DEVELOPMENT SERVICES
ENGINEERING DIVISION
156 S. BROADWAY, SUITE 150
TURLOCK, CA 95380

City Project No.: 18-35

Addendum No.: 1

PROJECT TITLE: Corp Yard Transit Parking Extension

C5.1

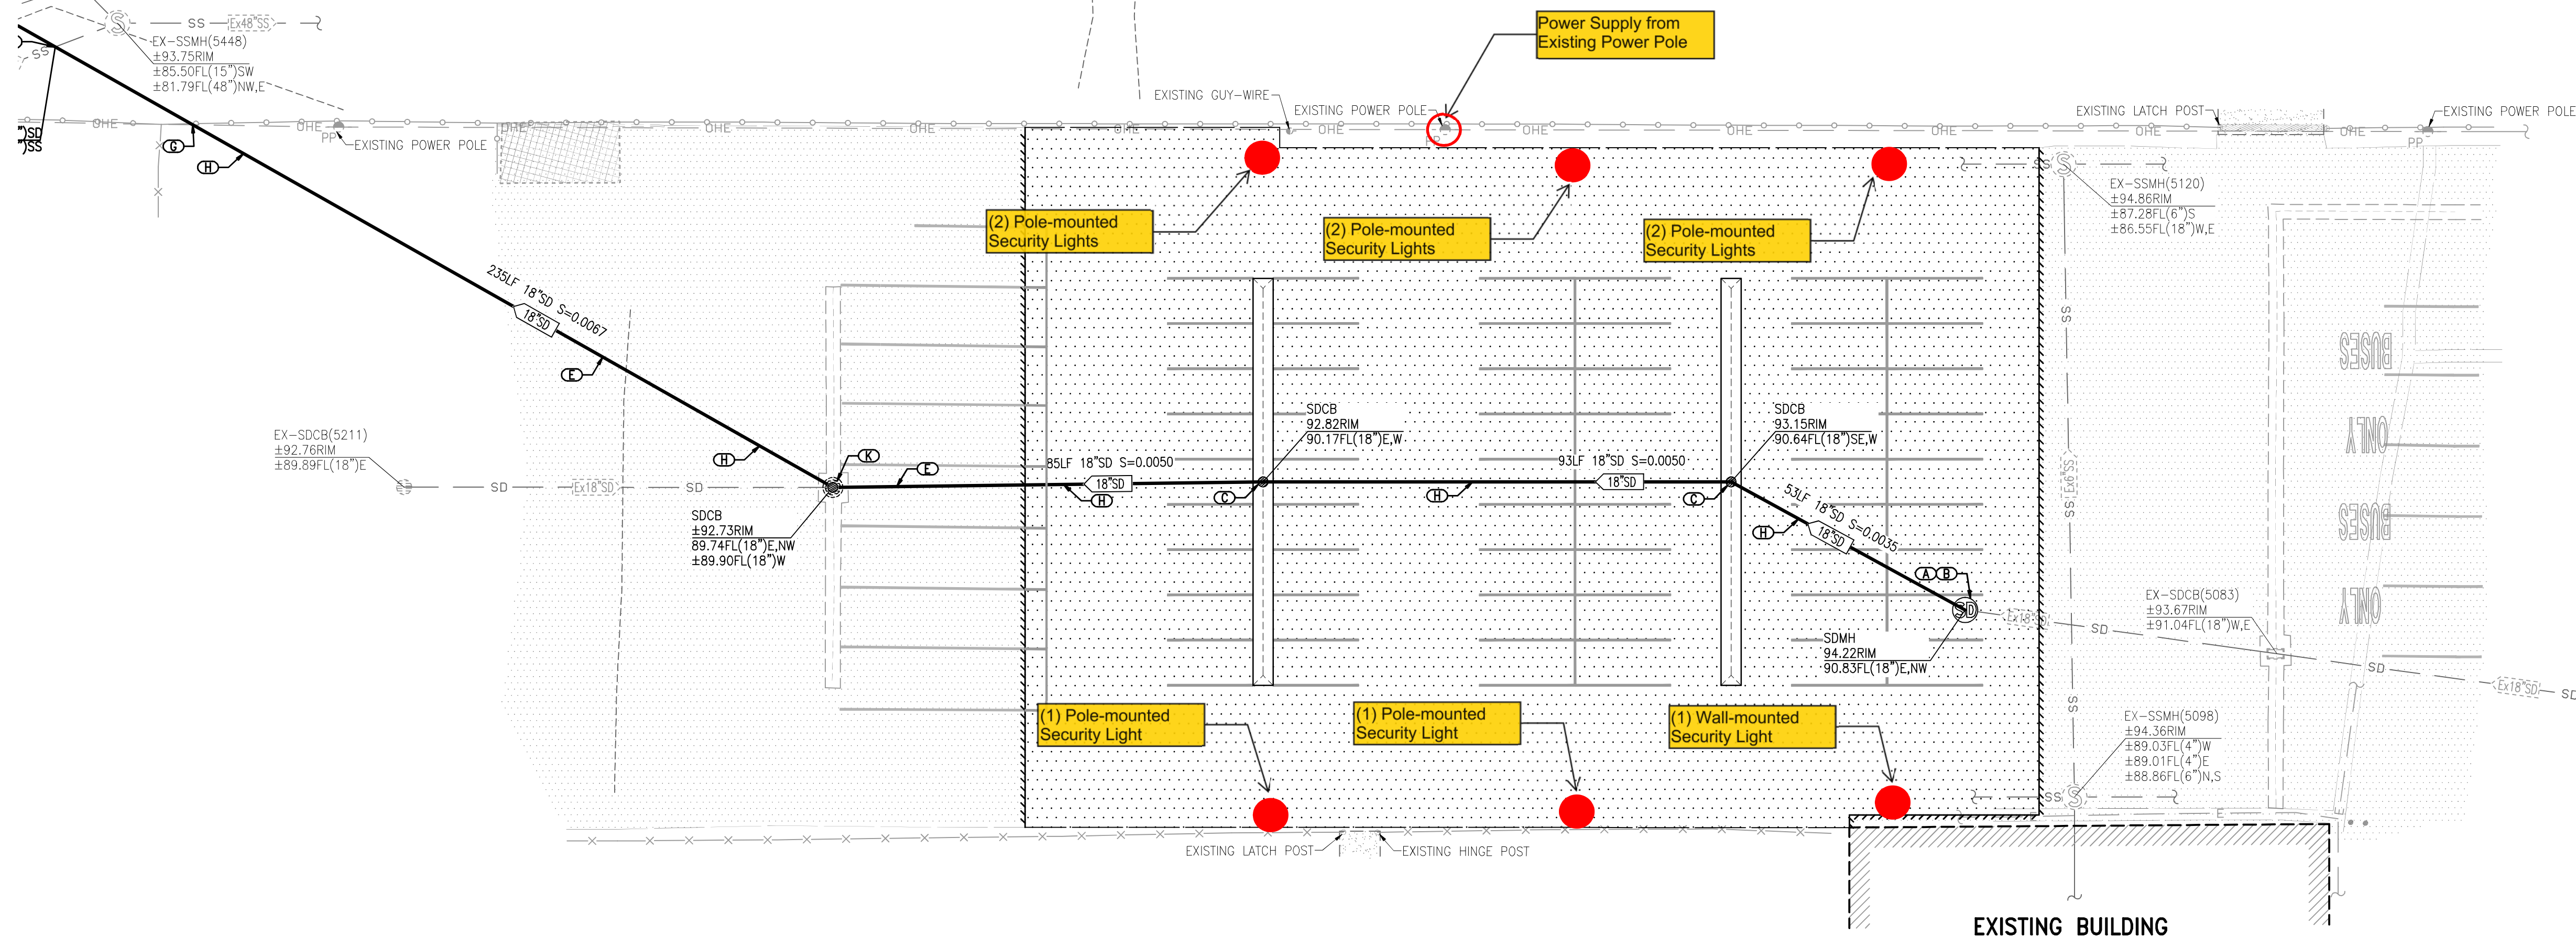
1. Sheet C2.1 – Keynote K – Existing SD line shall be abandoned in place, not removed. Contractor shall fill pipe with 1-sack slurry and cap ends.
2. Sheet C5.1 – Keynote H states to maintain at least 12” of cover. Is this from top of AC or subgrade? Please advise on areas where 12” of cover cannot be obtained.
 - a. 12” of cover is from top of pipe to top of AC.
